Remington Arms Company, Inc  
March 1, 1999

To: Rich Kosko, The Hanson Group  
Subject: Receiver Insert Part Changes (Dwg. E-300327)

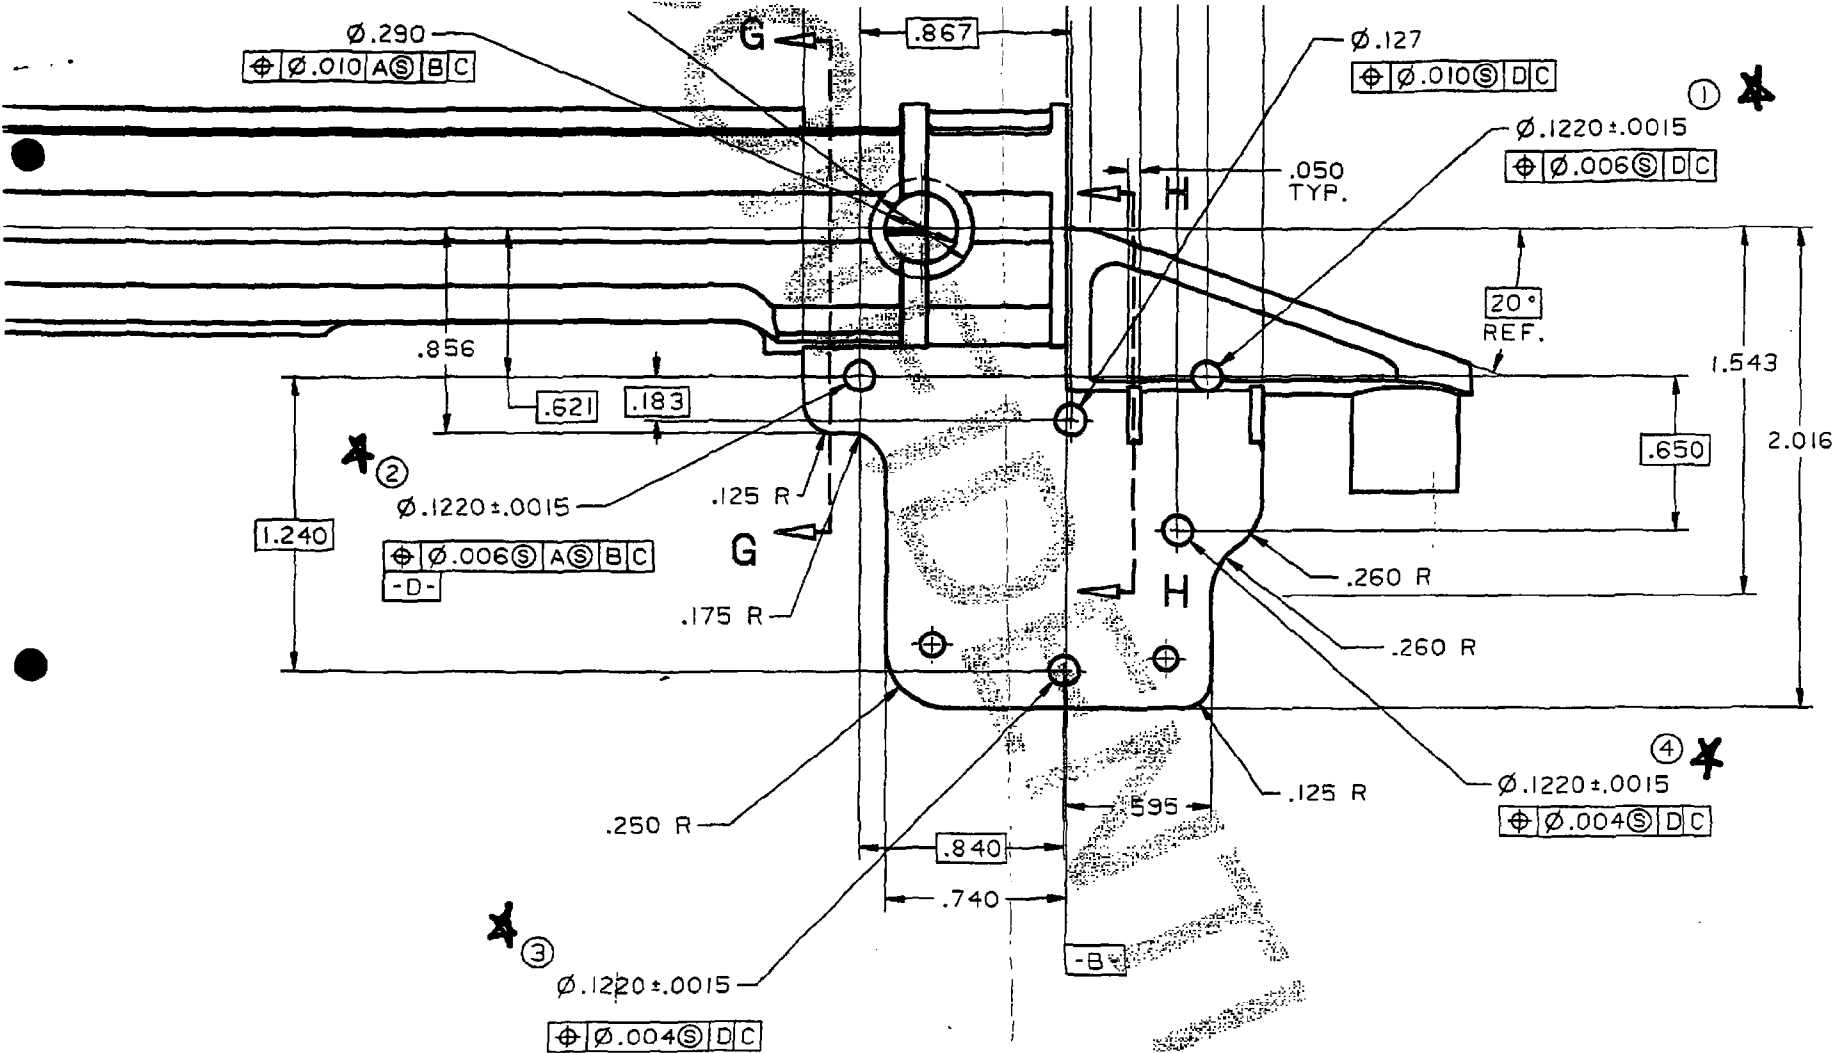
Please find attached a partial section of Drawing 2E-300327, receiver insert. Please note the dimension and tolerance changes for the four holes marked. Based on design requirements, I was able to increase diametral tolerance. To obtain proper fit of the mating cross pin, the diameter of the holes required adjustment. Drawing changes are called out as 1,2,3, and 4 as highlighted. A complete drawing will be mailed today, overnight to your attention. Not shown on the included partial section is design change number 5, which removed a duplicate callout for a .124 diameter hole. Upon receipt of the complete drawing please review, if you have questions please call.
